**MOORE PUBLIC SCHOOLS -  
EARLYWINE ELEMENTARY  
MEDIA CENTER ADDITION**

-----  
**ADDENDUM NO. 2**

October 22, 2024  
-----

**11** SECTION  
3/4" = 1'-0"

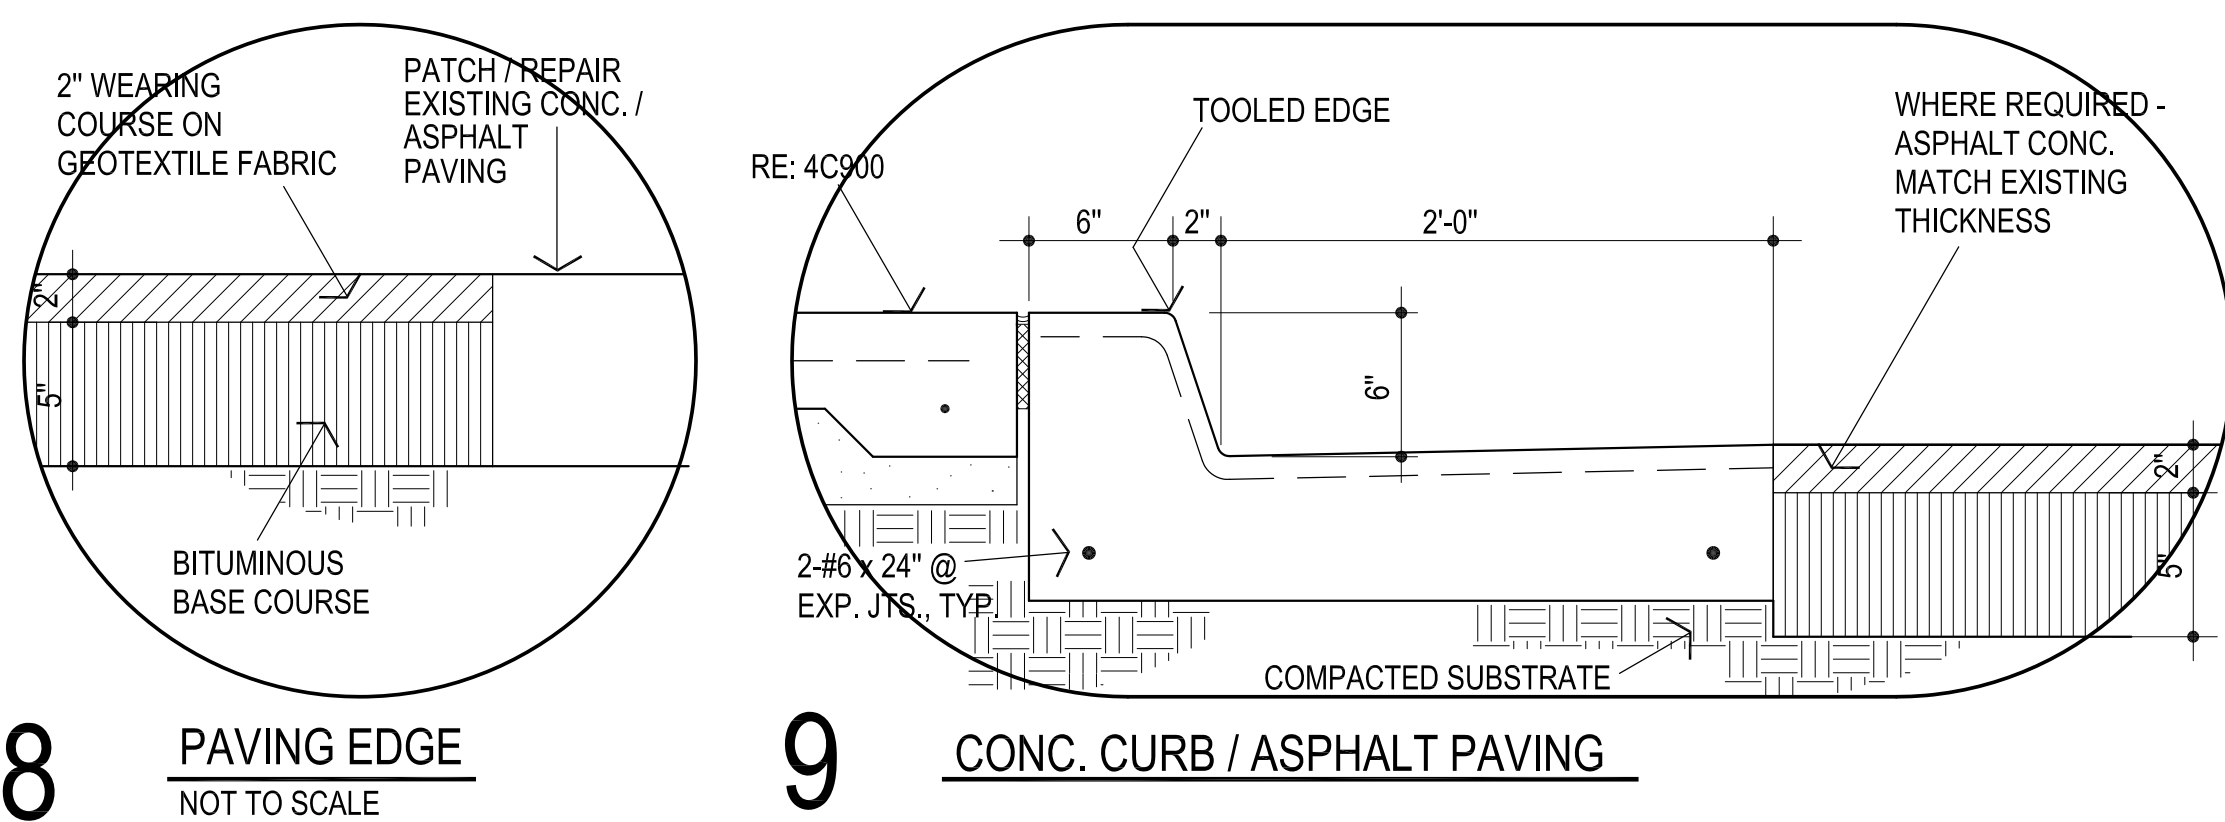
1. Sheet C900, Detail 11, Section: added detail in its entirety. Refer to attachment.

"RUB" ALL EXPOSED  
CONCRETE FOOTING  
@ STAIRS & LANDING

**1 SOUTH ELEVATION**  
1/8" = 1'-0"

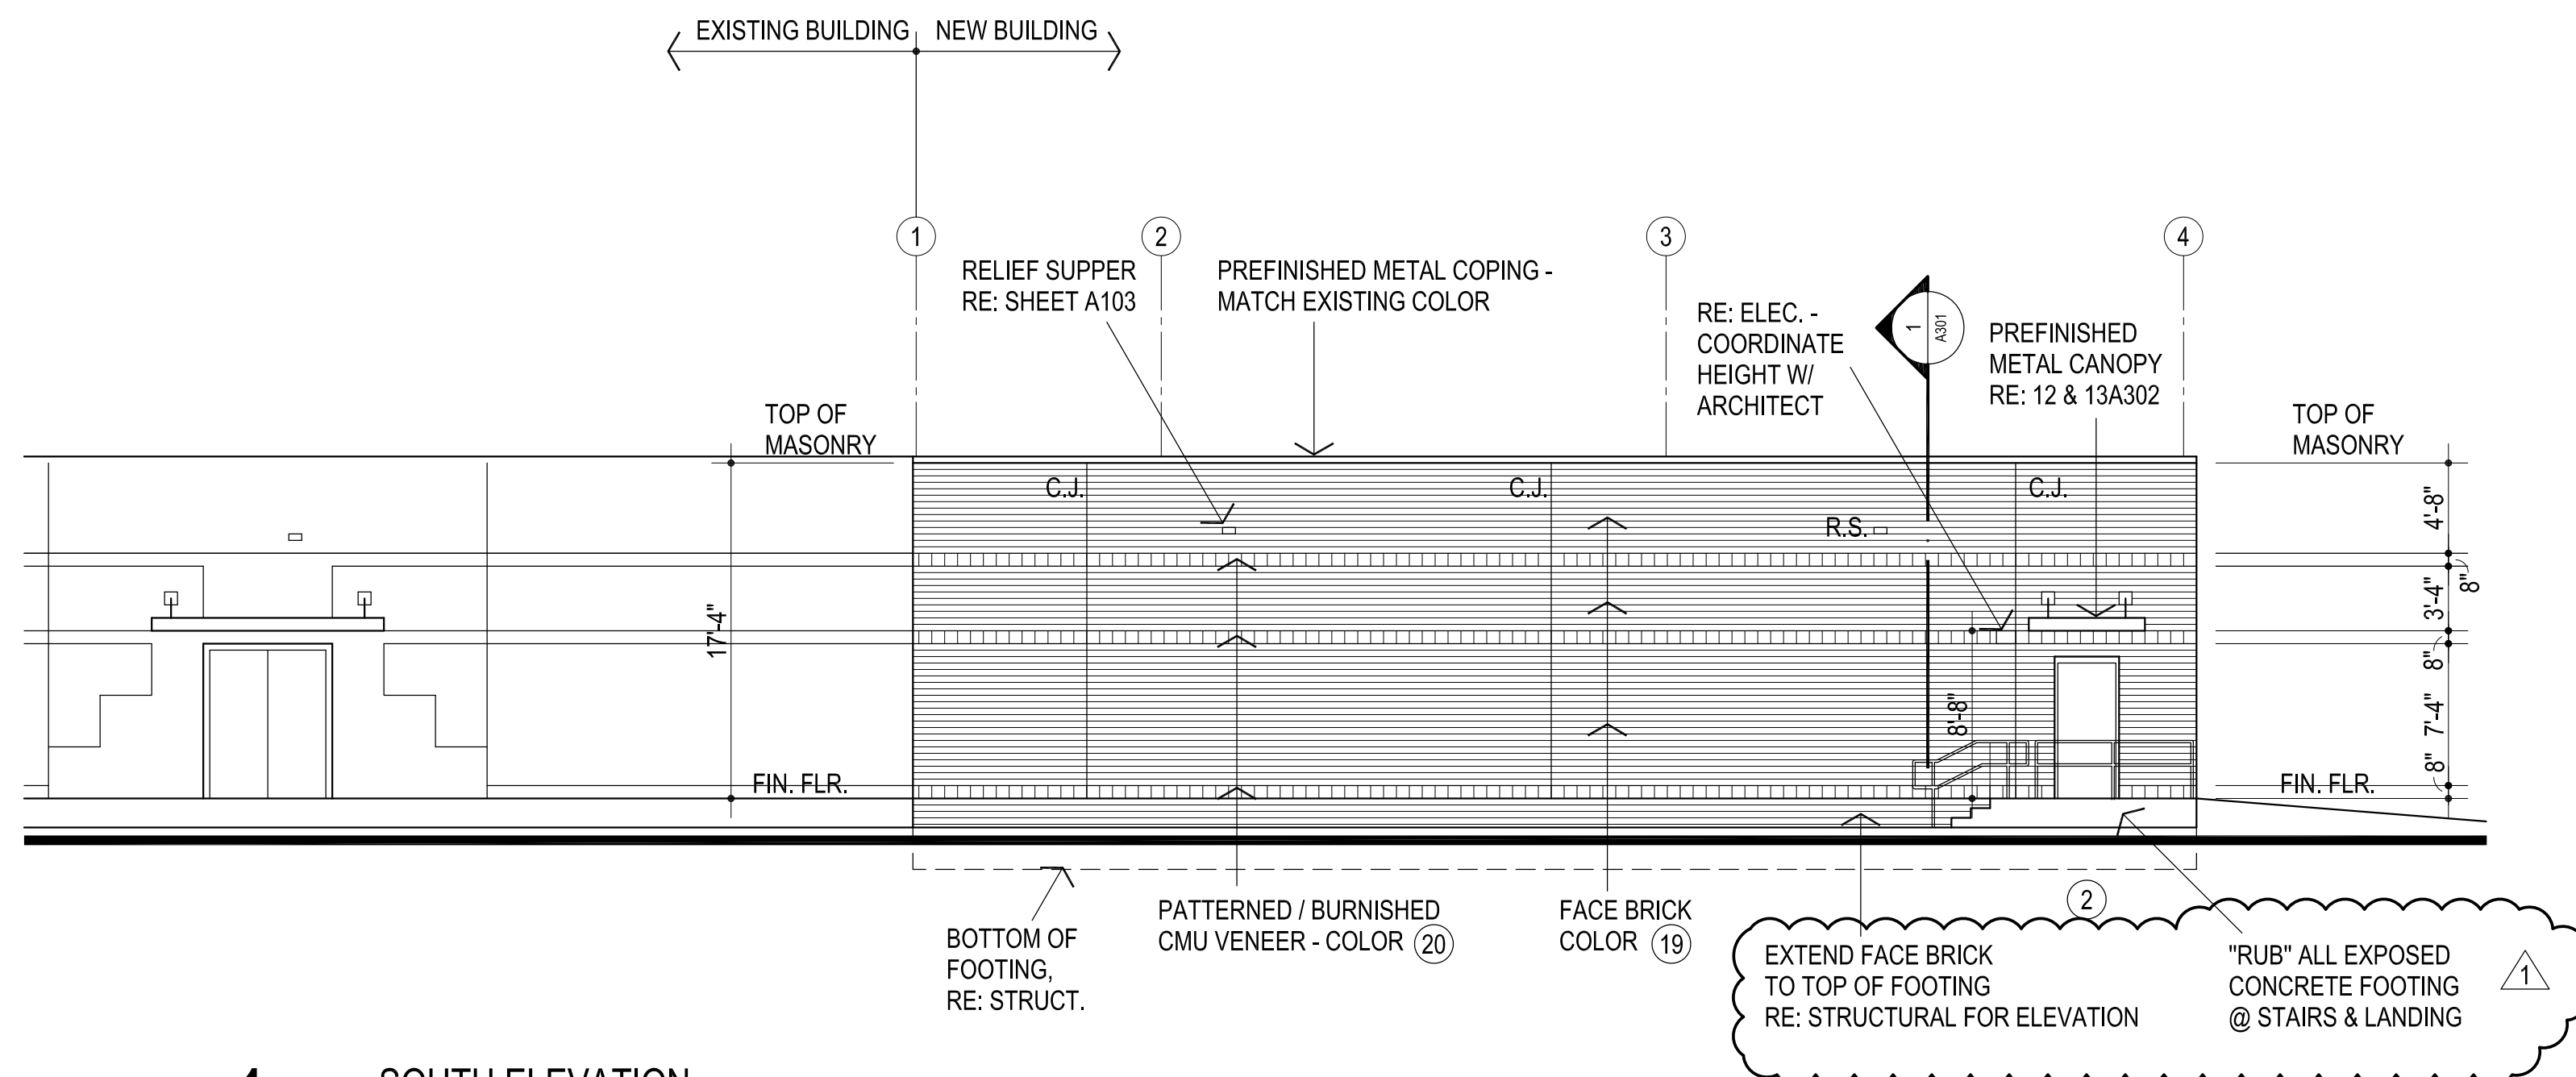
1. Sheet A201, Detail 1, South Elevation & Detail 2, East Elevation: added notes concerning the addition of rubbing the exposed concrete at stoop. Refer to attachment.
2. Sheet A201, Detail 4, Partial South Wall Room #1: provide thin brick #19 in lieu of "burnished veneer" as indicated. Provide rubber wall base in lieu of "terrazzo base". Refer to attachment.
3. Sheet A302, Detail 5, Wall Section: added detail – replace sheet in its' entirety. Refer to attachment.
4. Sheet A401, Detail #1 – Elevation "C": revised reference. Refer to attachment.
5. Sheet A401, Detail #4, 3 Drawer Section: added detail. Refer to attachment.
